TRANSMITTAL OF SHOP DRAWINGS, EQUIPMENT DATA, MATERIAL SAMP												
MANUFACTURER'S CERTIFICATES OF COMPLIANCE For use of this form, see ER 415-1-10; the proponent agency is CECW-CE					CE.		DELIV	ERY VIA	Email		TA – 03	31
	SECTION I - REQU	JEST FOR APPI	ROVAL OF THE	FOLLOWING	ITEMS (This	section	will be in	itiated by the	contracto	r)		
TO:	NAVFAC				vd., Suite				CHECK ONE: THIS IS A NEW TRANSMITTAL OTHIS IS A RESUBMITTAL OF TRANSMITTAL		MITTAL OF	
transmitta	CATION SEC. NO. (Cover only one section) No MDL # – Mis-Located ICF reinforcement		PROJECT TITL P021 Middle So Corps Base Qu	chool/High Sc	hool Replacem	ent, Mar		IS TRANSMIT DFIO ⊠ GA	ΓTAL IS F □DA			⊃DA/GA

Corrective Action Plan Submittal Quantico Middle/High School

Corrective Action Plan Submittal Number: 31

Corrective Action Plan Description: ICF Reinforcement

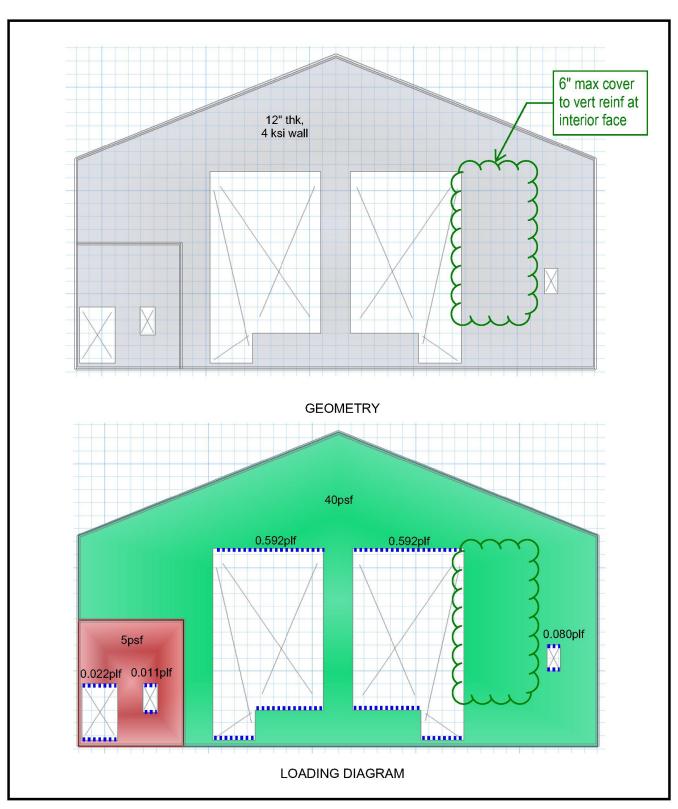
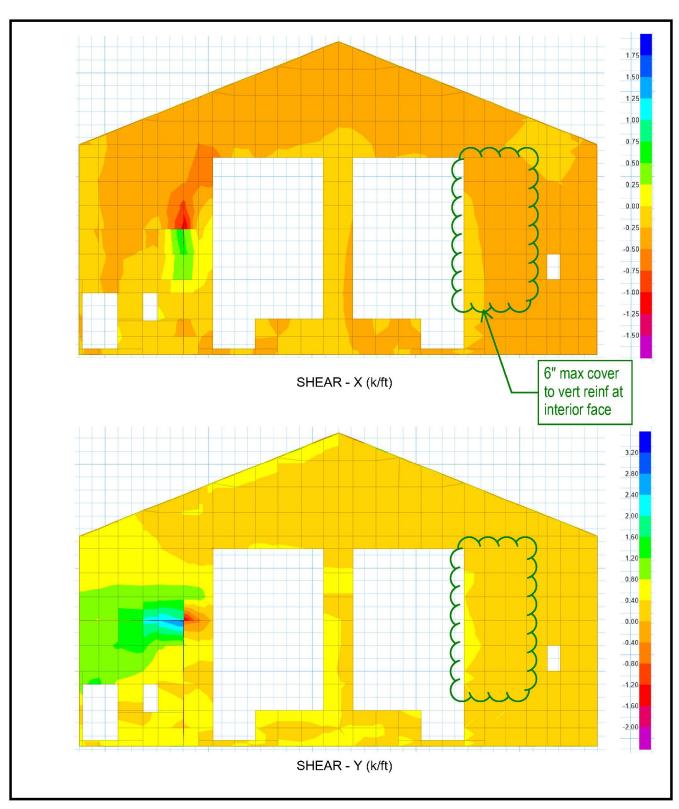
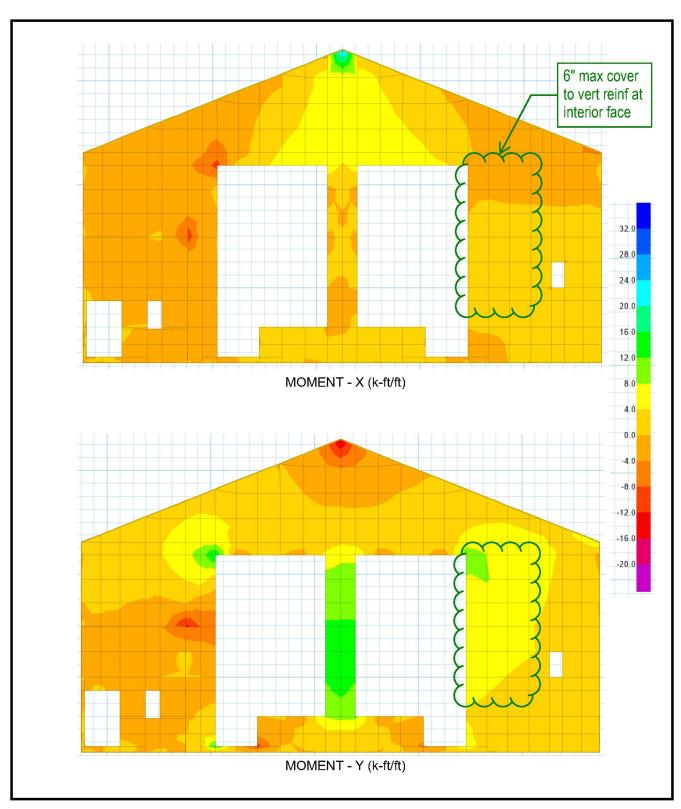
provision is violated at Grid 28. Clear cover should be verified at all 12" walls.
